RE: P.Z. 02-2024 18009 and 18045 N. Outer 40 Rd. (Gumbo Flats Properties, LLC): A request for an ordinance amendment to create a new "PI" Planned Industrial District for two parcels zoned "M3" Planned Industrial District, "NU" Non-Urban District and "PI" Planned Industrial District, and totaling 78.07 acres located on the north side of Outer 40 Road (16W310045 and 16W240041).

Planning Commission Staff Report

Petition: **P.Z. 02-2024 18009 and 18045 N. Outer 40 Rd. (Gumbo Flats Properties, LLC)**: A request for an ordinance amendment to create a new “PI” Planned Industrial District for two parcels zoned “M3” Planned Industrial District, “NU” Non-Urban District and “PI” Planned Industrial District, and totaling 78.07 acres located on the north side of Outer 40 Road (16W310045 and 16W240041)

PRELIMINARY DEVELOPMENT PLAN

2010

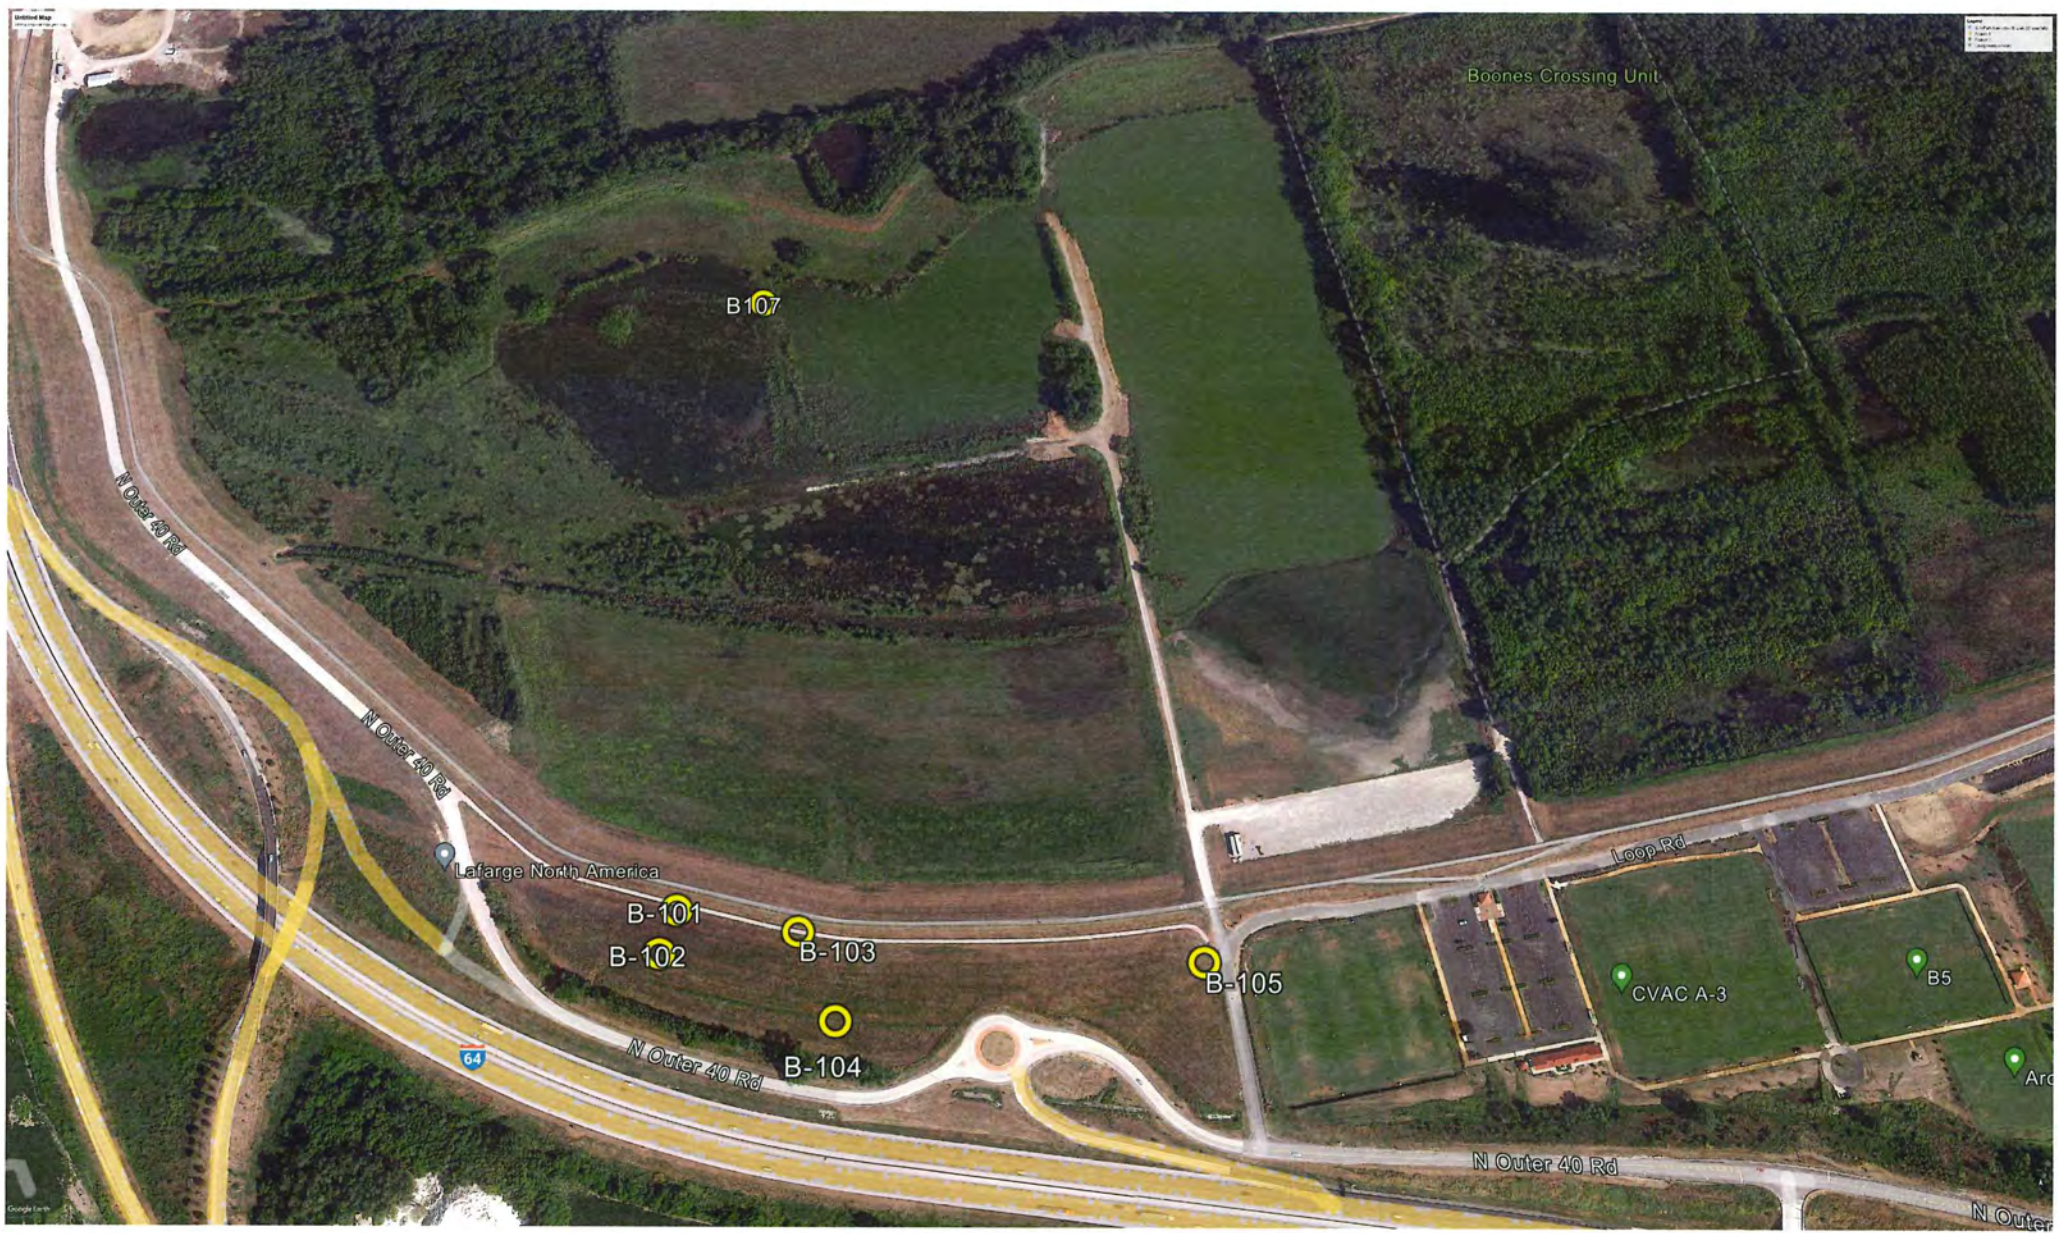
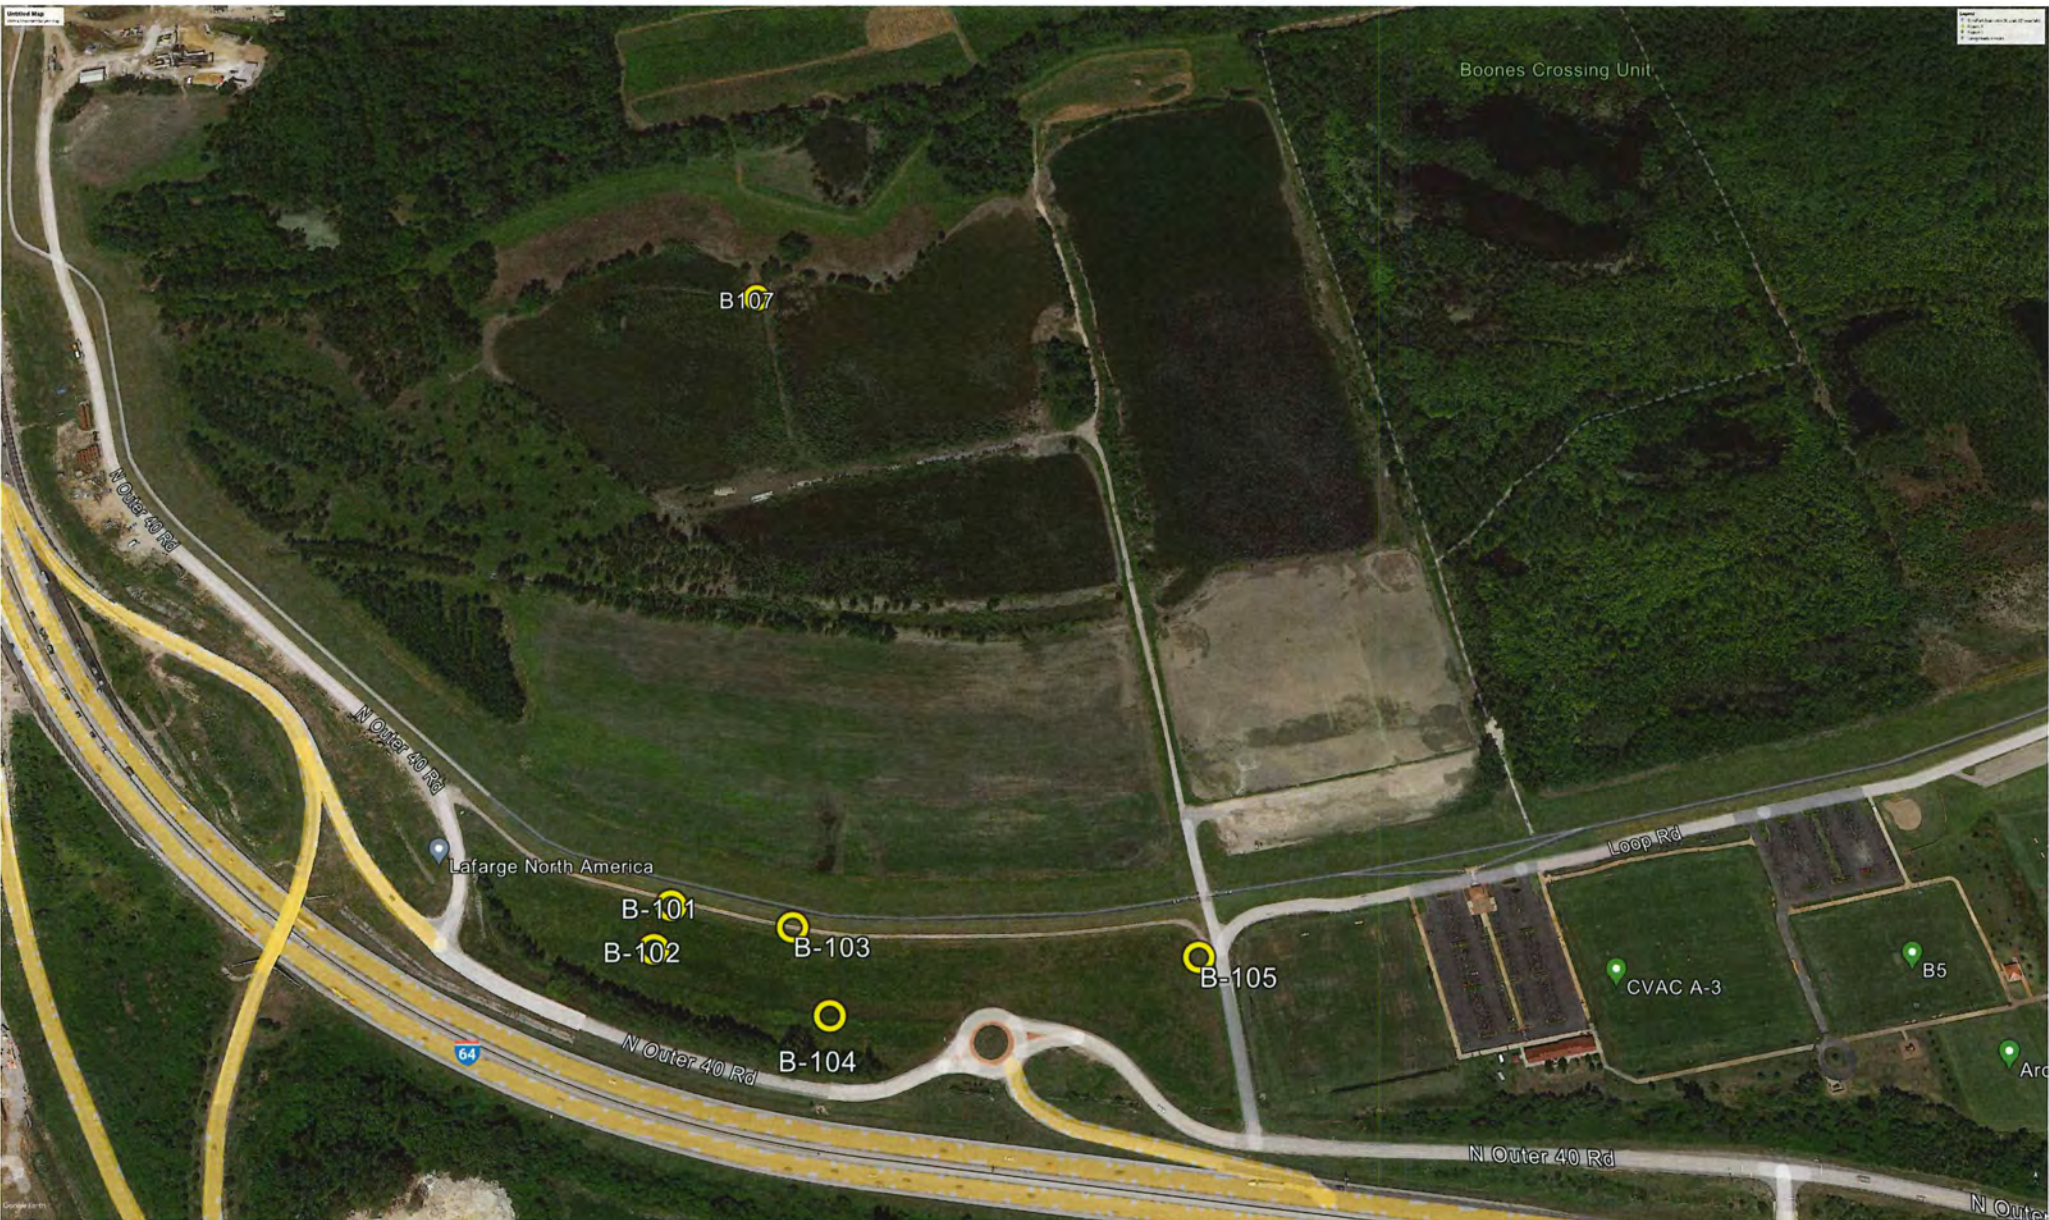
3. The City of Chesterfield Comprehensive Plan designates the subject site as "Conservation" and indicates properties within this designation should, "focus on preservation." Provide information on how the development team will have consistency with Conservation land use designation.

Response: Previous discussions with the city determined that the city's Master Plan consultant was not asked to study this property because of City and Levee district ownership at the time of the comprehensive plan. Gumbo Flats Properties LLC / Gateway Studios is enhancing the existing openspace of the land assemblage. Currently a Site Development Plan is being processed through the City demonstrating the overall enhancement and improvements to the previously disturbed areas. They are constructing passive recreational amenities for their private use where borrow pits were previously dug and illegal dumping occurred. Attached are a series of aerial photos from 1990 – 2015 illustrating farming and borrow operations.
